Item ID: D412-664-209

Item Name: Aft Crosstube - Low Standard

**D412-664-249**  
**ASSEMBLY DETAIL**

DRAWING NO. D412-664-249	TITLE CROSSTUBE ASS'Y (412 LOW AFT)	REV. B	DART AEROSPACE LTD ENGINEERING ORDER		D.E.O. NO. D412-664-249-B-1	SHEET NO. SHEET 1 OF 2	SCALE NTS
DRAWN 9P	CHECKED SC	MFG. APPR. E	APPROVED MD		DE APPR. H		
DATE 11.05.25	DATE 11.05.31	DATE 11.05.31	DATE 11/05/31		DATE 11.05.31

DRAWING NO. D412-664-249	TITLE CROSSTUBE (412 LOW AFT)	REV. B	DART AEROSPACE LTD ENGINEERING ORDER	D.E.O. NO. D412-664-249-B-3	SHEET NO. SHEET 2 OF 3	SCALE NTS
DRAWN 9	CHECKED A	MFG. APPR. A	APPROVED MD	DE APPR. H		
DATE 12.08.21	DATE 12.08.22	DATE 12.08.29	DATE 12.08.29	DATE 12.08.29	DATE 12.08.29

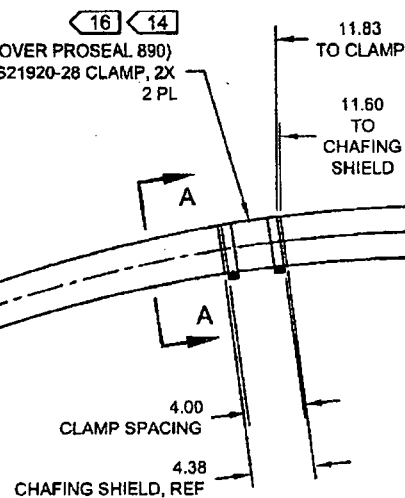
**CHANGE:**

**D412-664-249  
ASSEMBLY DETAIL**

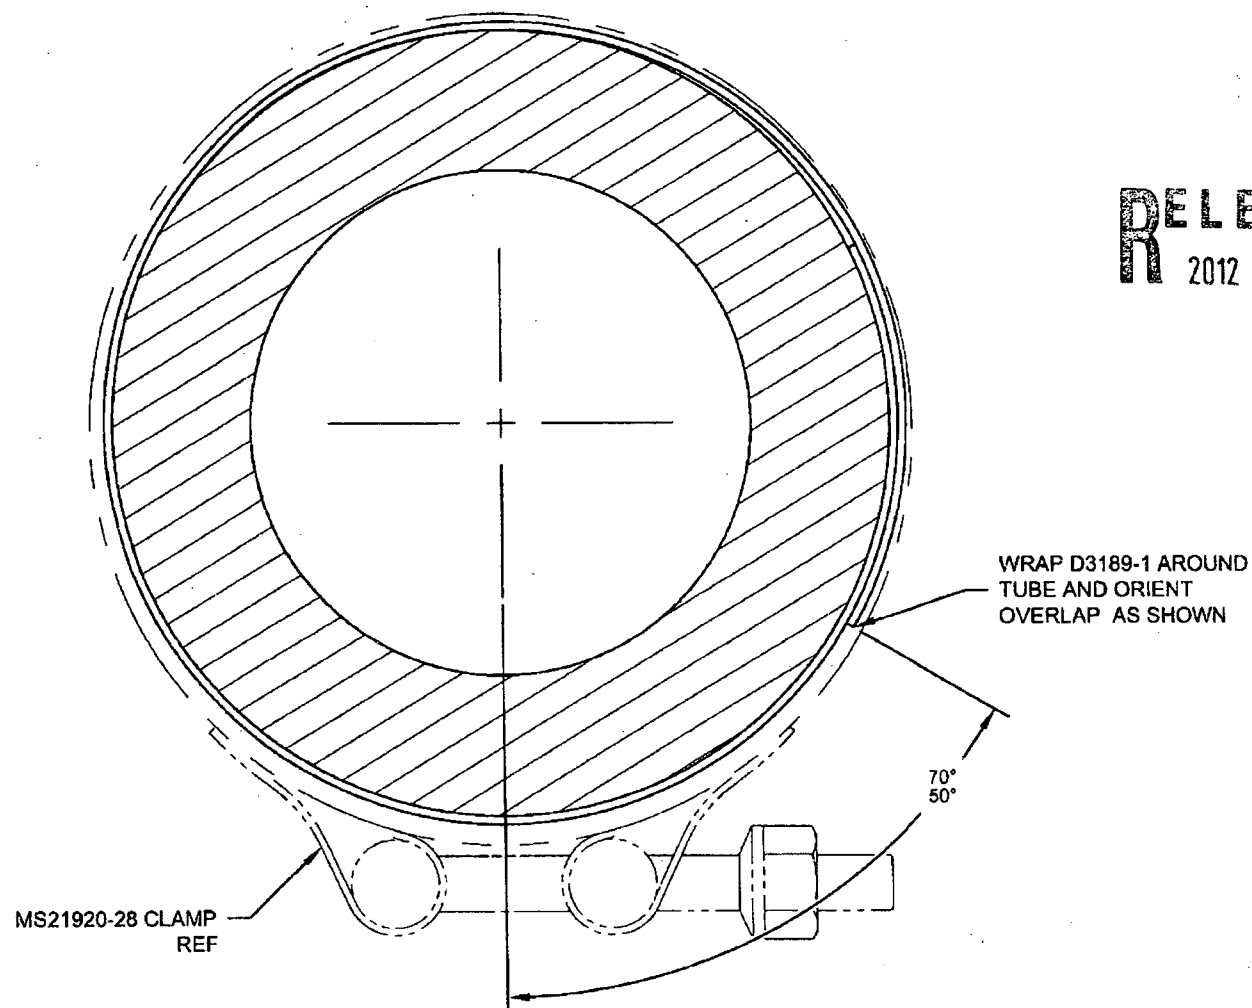
NOTE 14 AND 16 ON SHEET 1 IS AMENDED AS FOLLOWS:

- 14) INSTALL D2856-600-1009 ABRASION STRIPS WITH A 0.13 REF GAP ON BOTTOM SIDE OF CROSSTUBE PER QSI 035.
- 16) TORQUE CLAMPS 80 TO 100 IN-LB. ENSURE AT LEAST 1.5 THREADS SHOWING IN SAFETY AND THAT NUT HAS NOT BOTTOMED-OUT AFTER TORQUING.
